Planning Commission Regular Meeting | 5:30 PM

Wednesday, April 29, 2026

A. 0126 Miles End Lane - New Single Family Residence

Final Plan Review for New Home

Sheet
C1

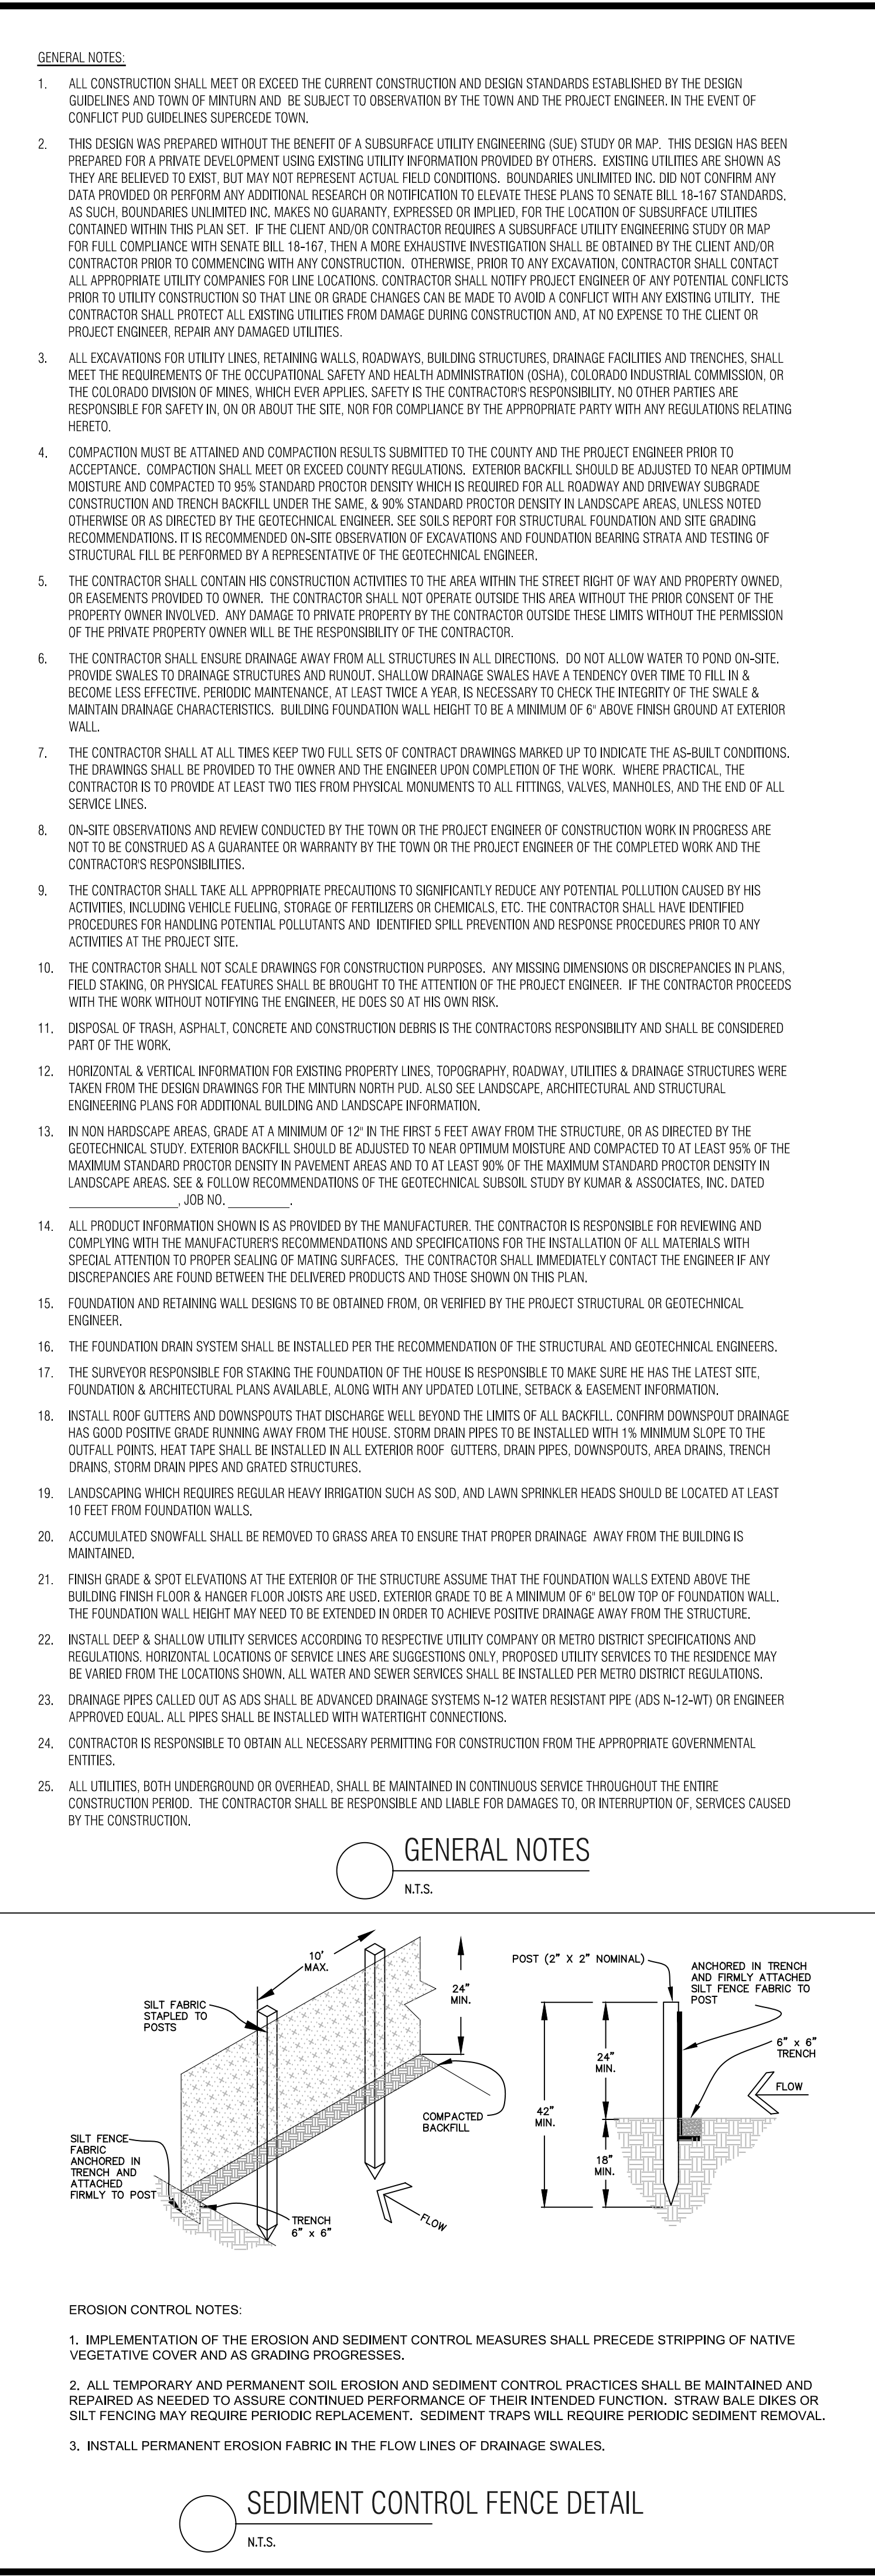
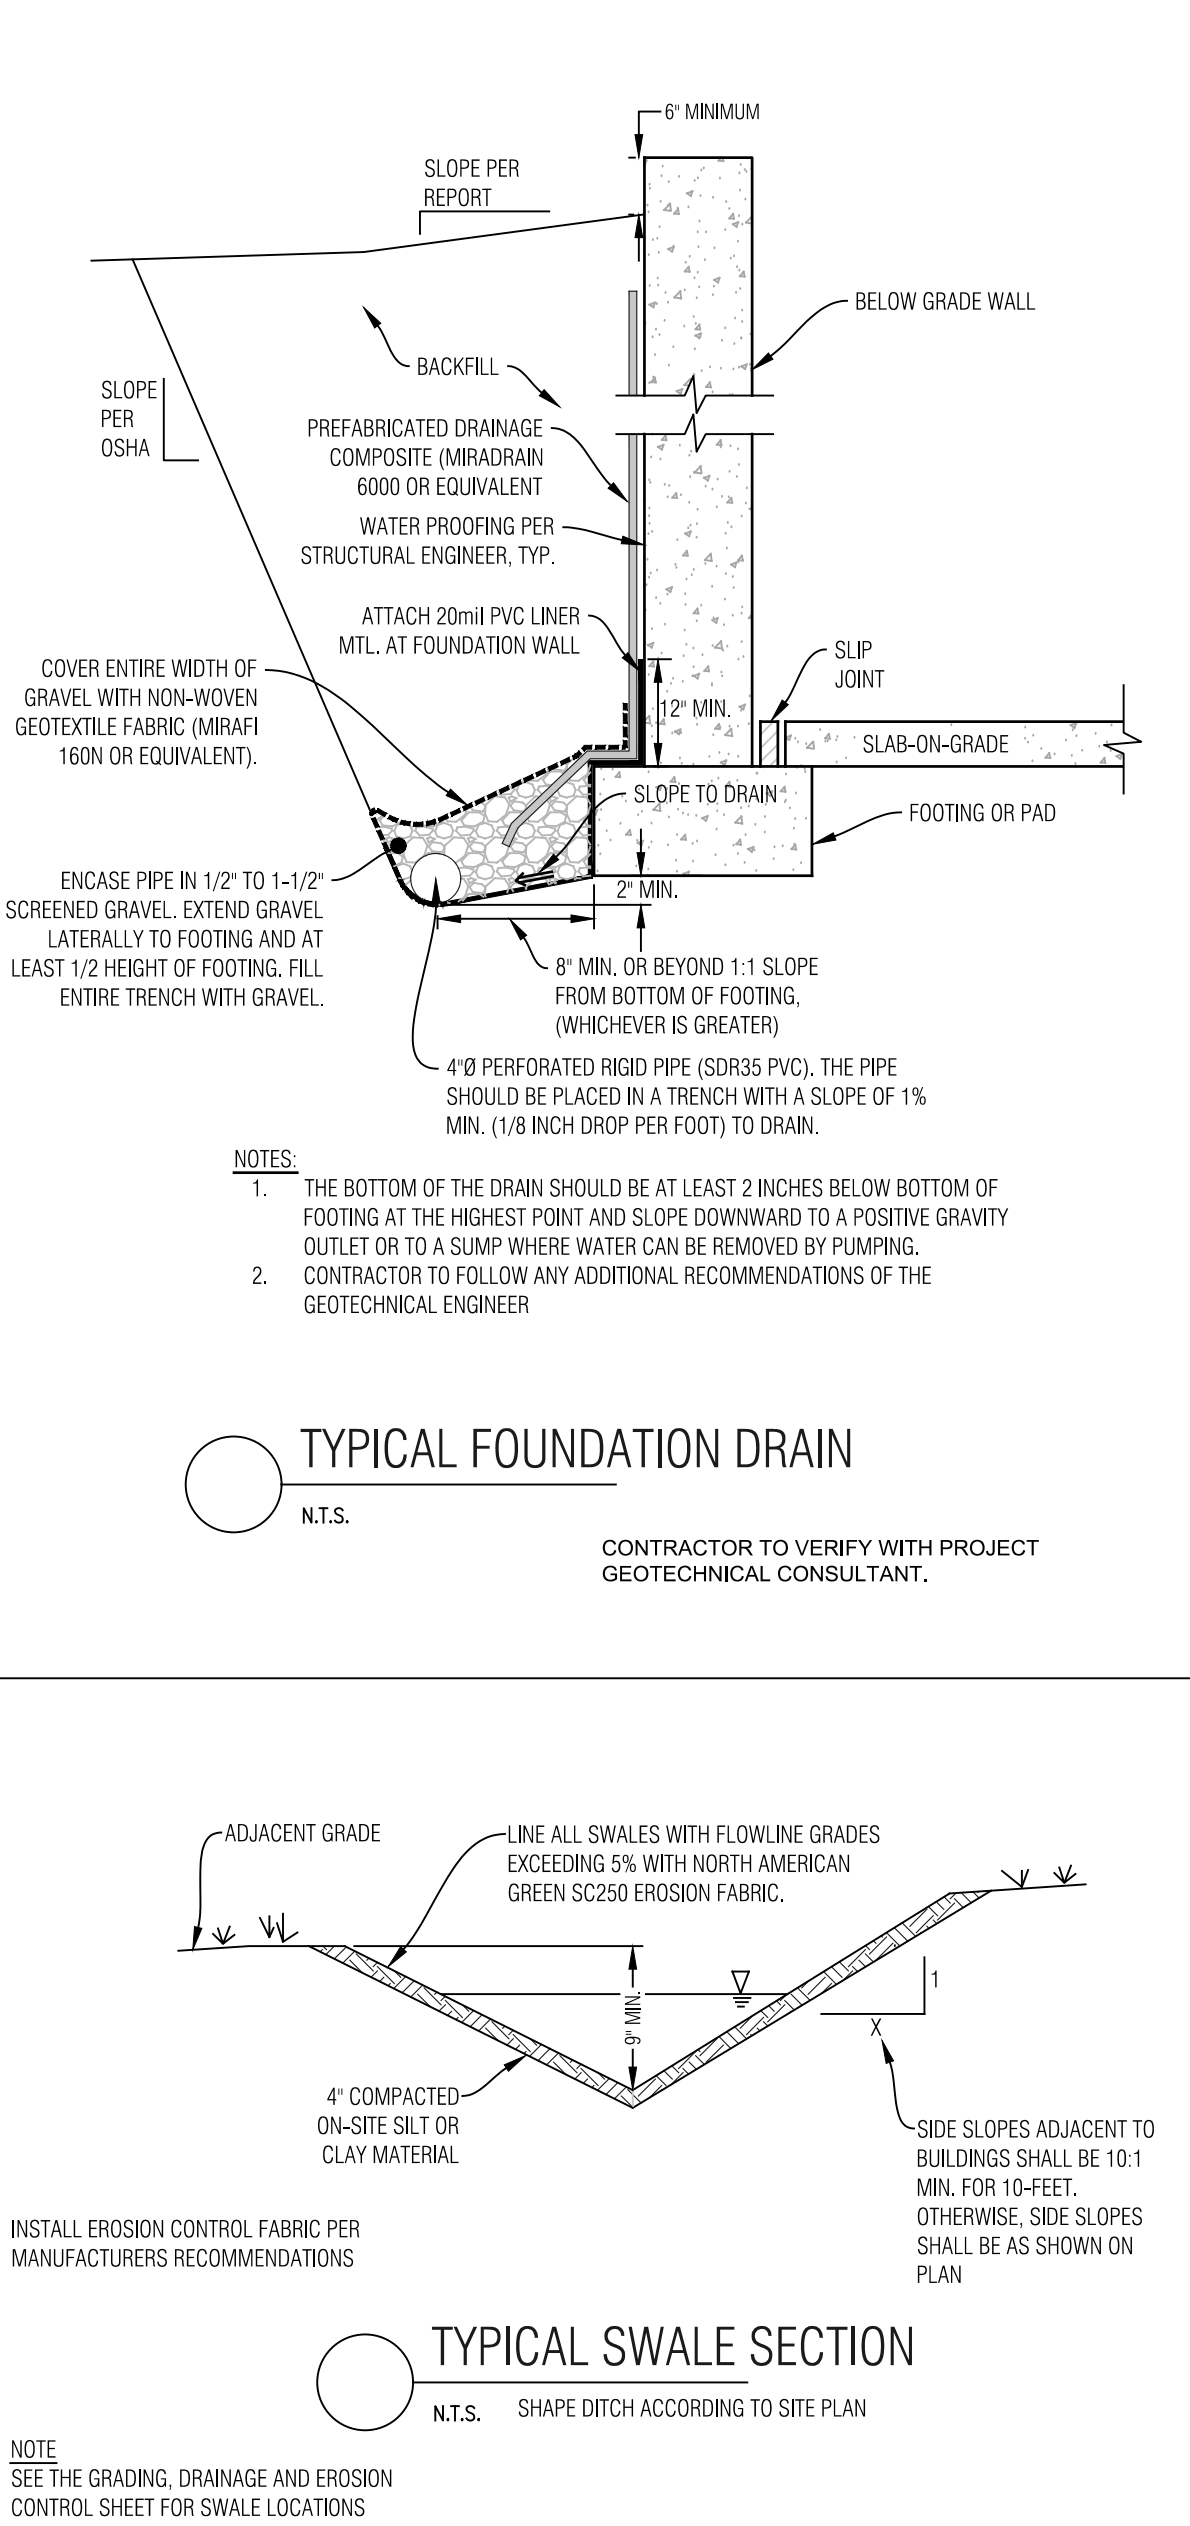
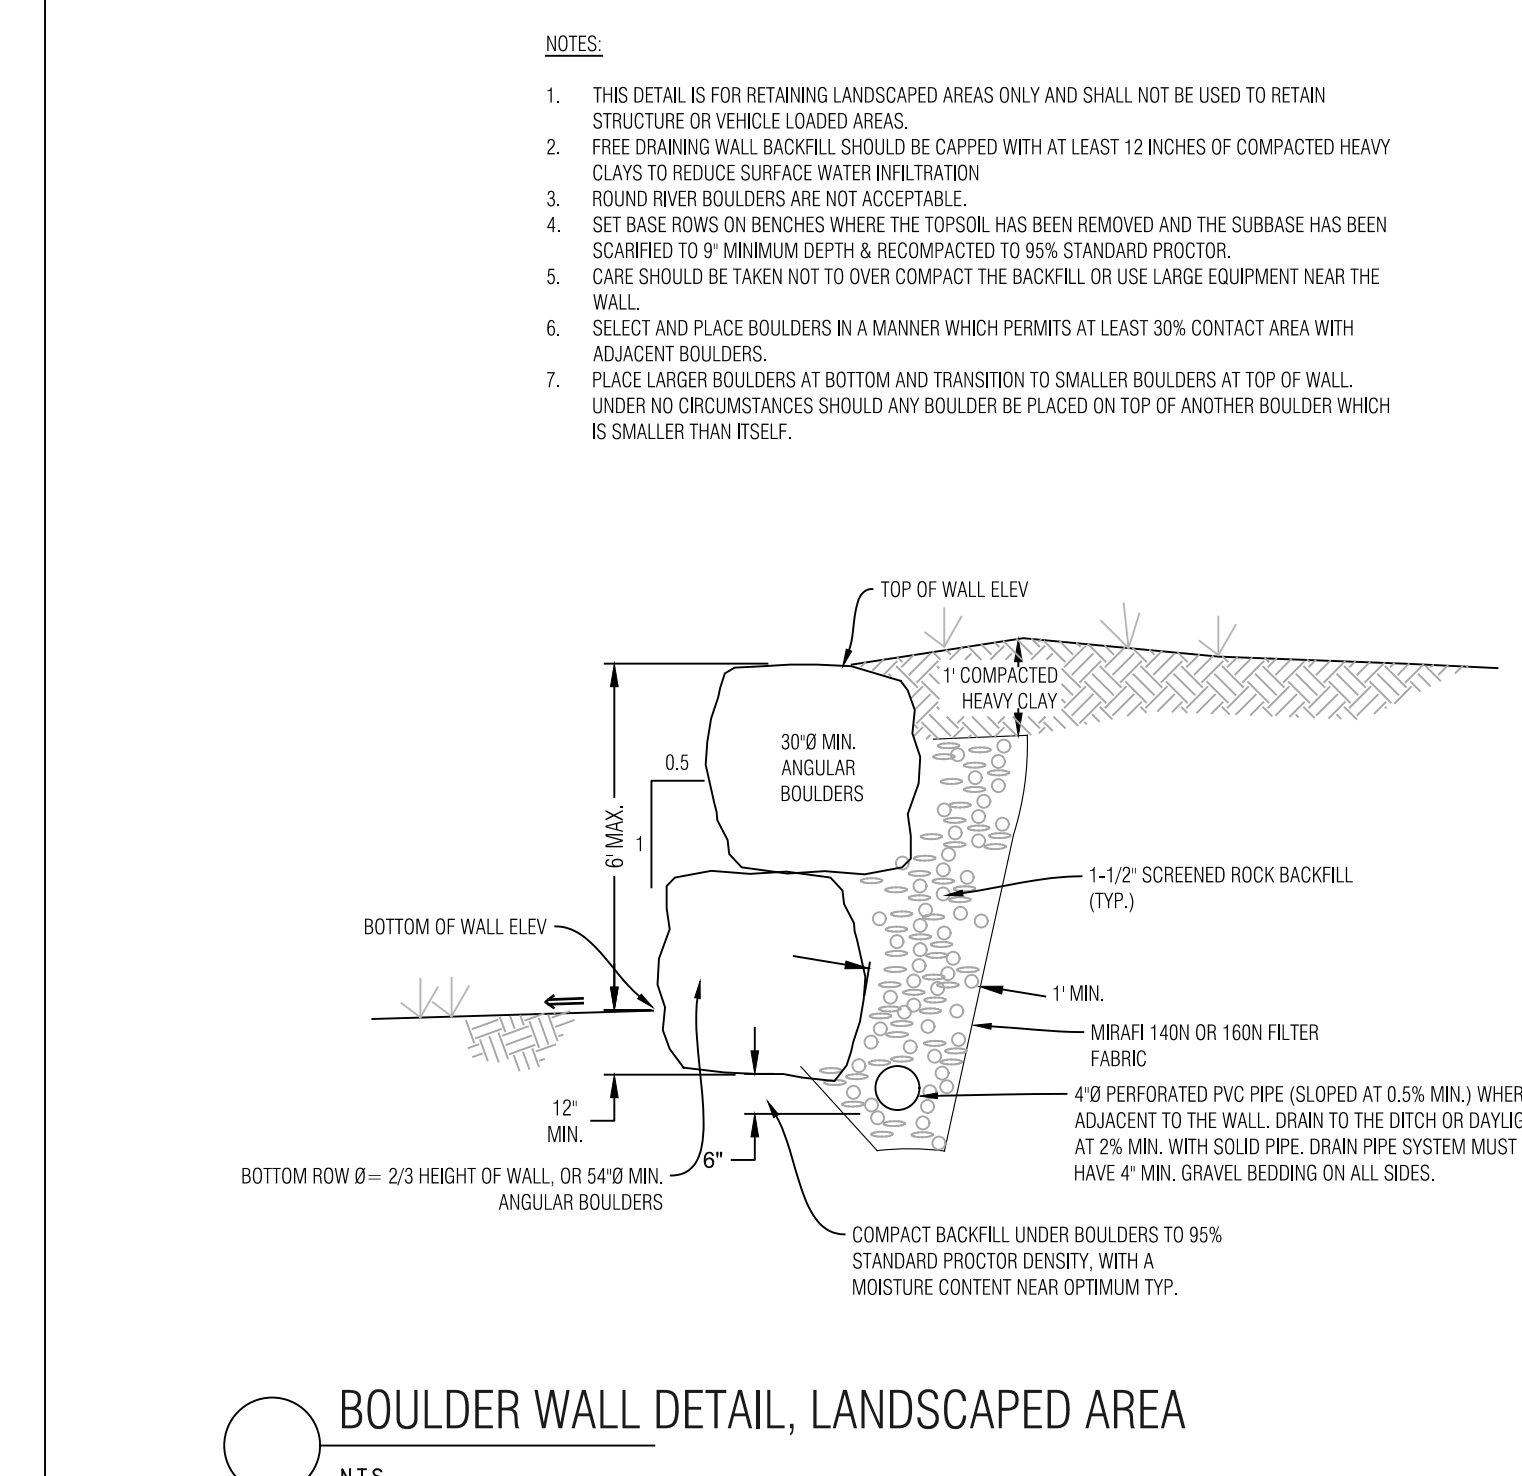
Sheet C1 of the Plans "*Lot 13, Minturn North PUD; Site Grading and Drainage Plan*" prepared February 4, 2026, by Boundaries Unlimited presents the proposed site grading and drainage. The Plan fulfills Grading and Drainage Plan requirements.
